PETITION FOR VARIANCE **APPLICATION**

Petition for Variance 680 Grand Canyon Drive, Suite #5 Dane County Humane Society

Dane County Humane Society

680 GRAND CANYON DRIVE - SUITE 5 MADISON, WI 53719

PROPOSED FLOOR PLAN / WORK AREA / NOTES

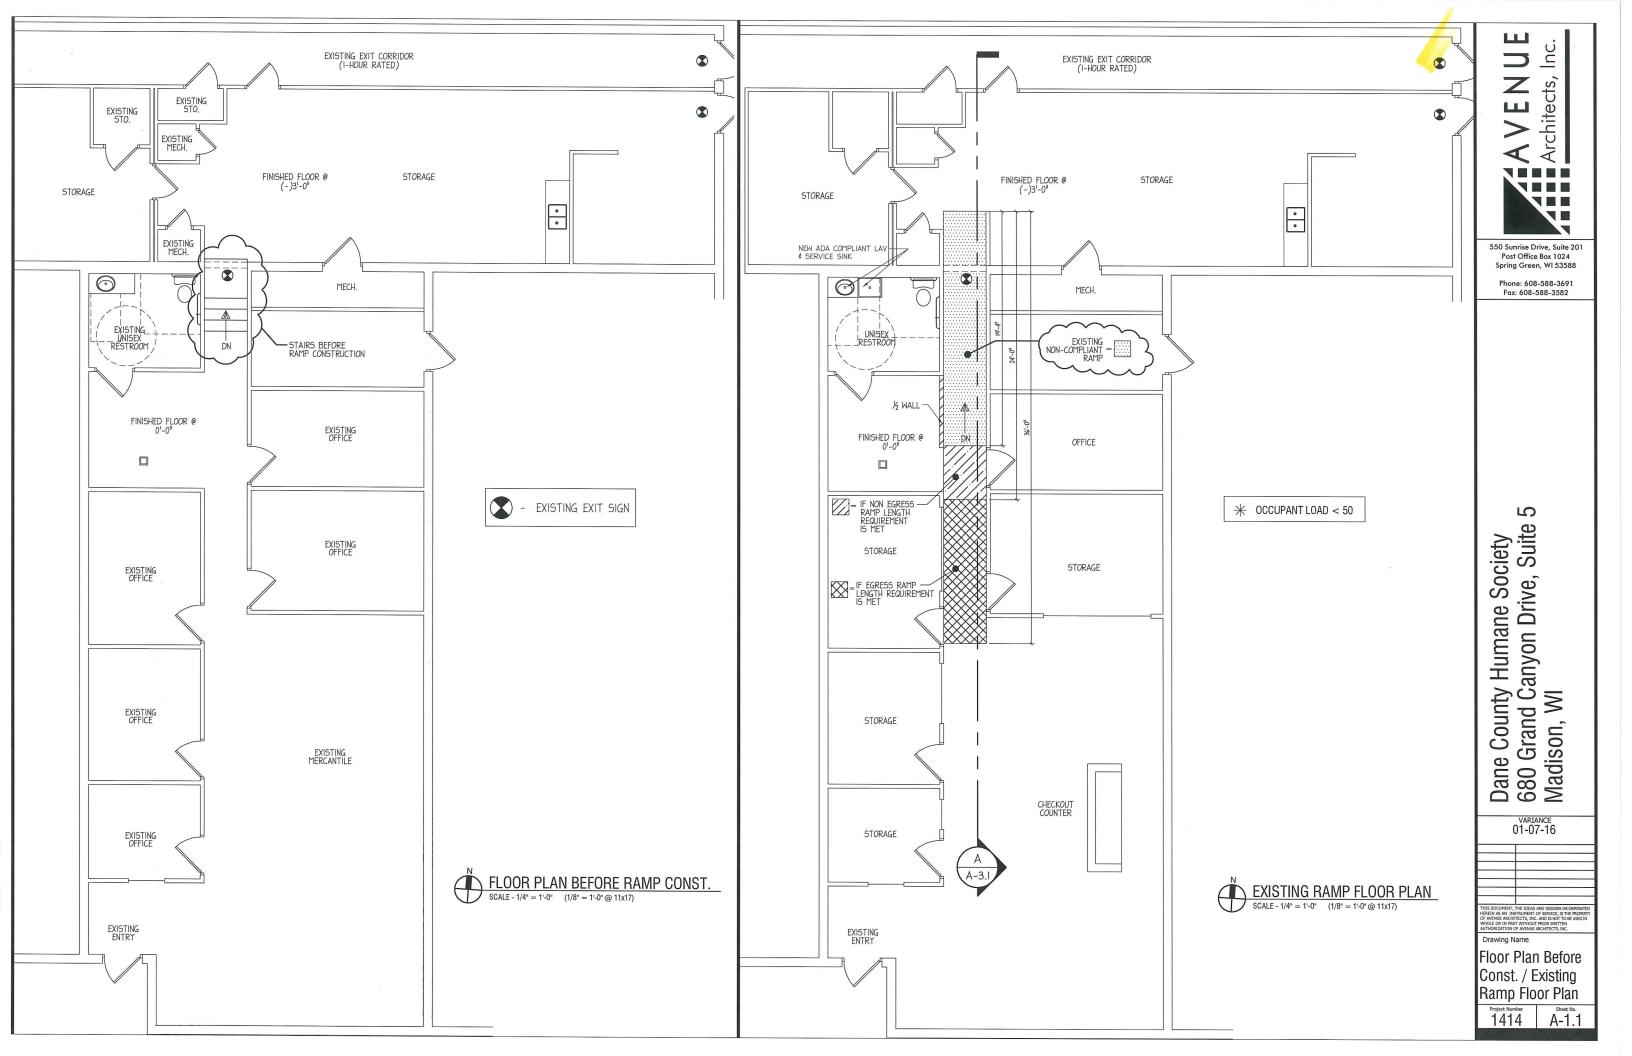
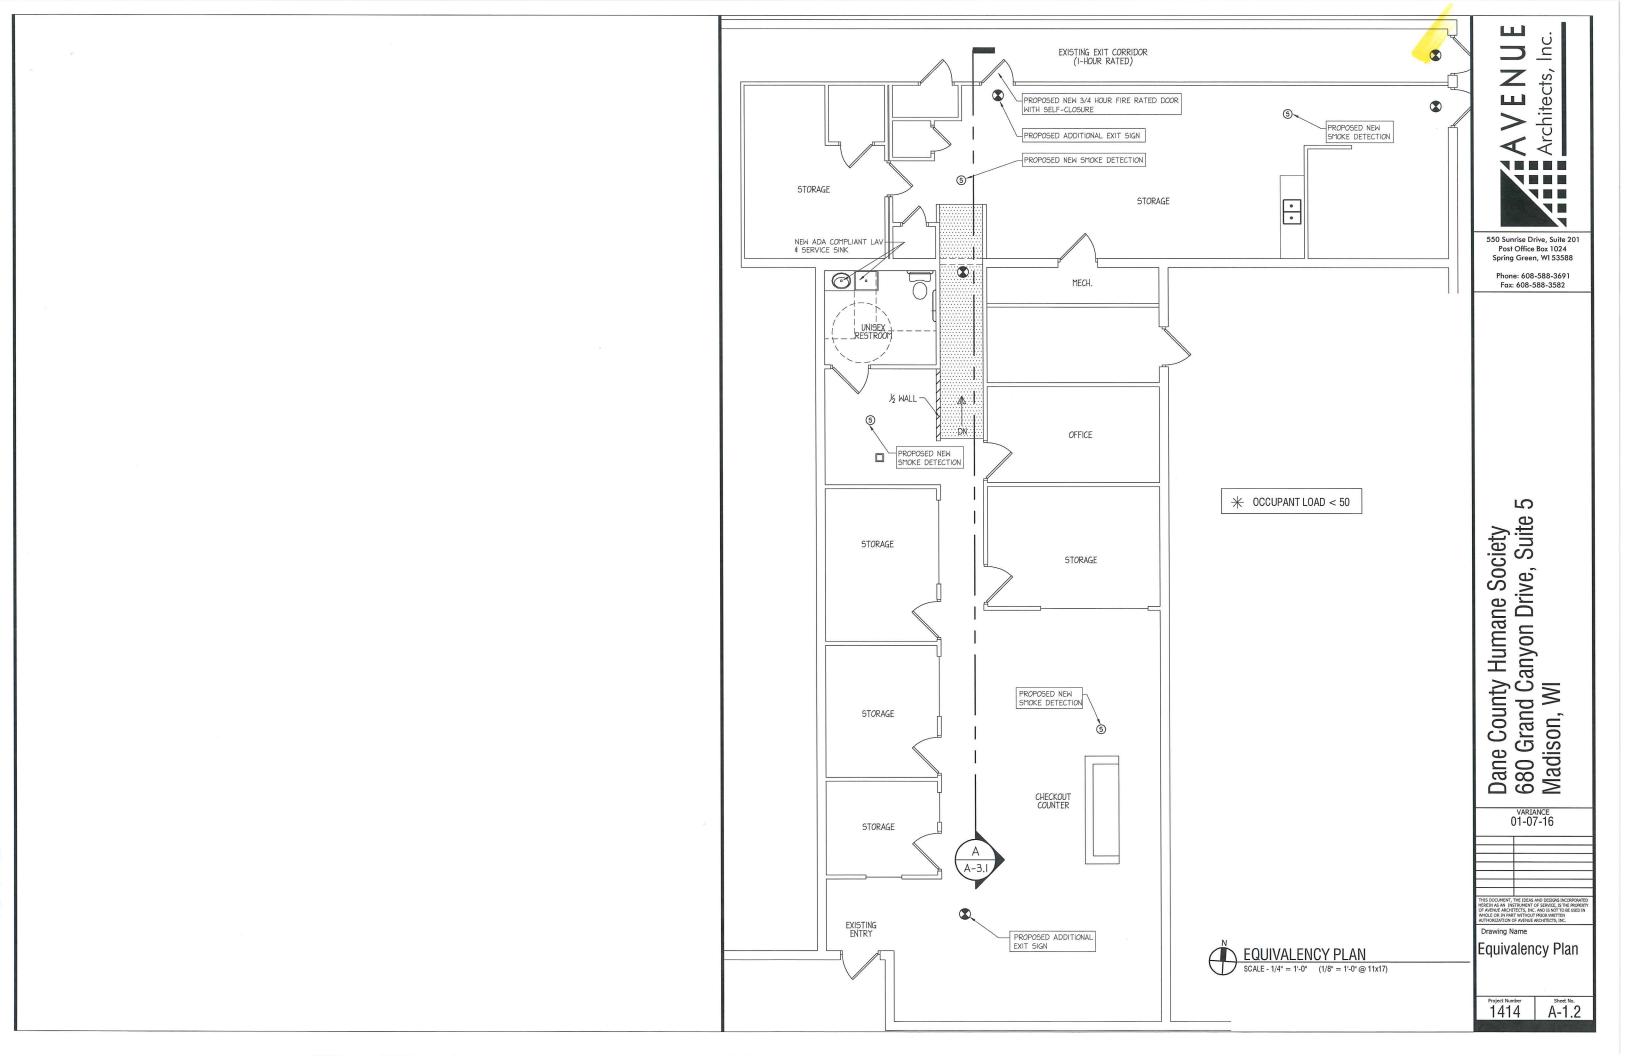
The existing ramp does not meet the maximum slope requirements for egress. Proposed equivalency is proposed providing the following (see Sheet A-1.2):

- 1. Add a ¾ hour rated door and exit sign at the bottom of the ramp, which provides access to the existing exit corridor, which provides an additional exit from the lower floor level storage.
- 2. Add two single station smoke detection devices in the lower floor level (none currently exist).
- 3. Add two single station smoke detection devices to the main floor level (none currently exist).
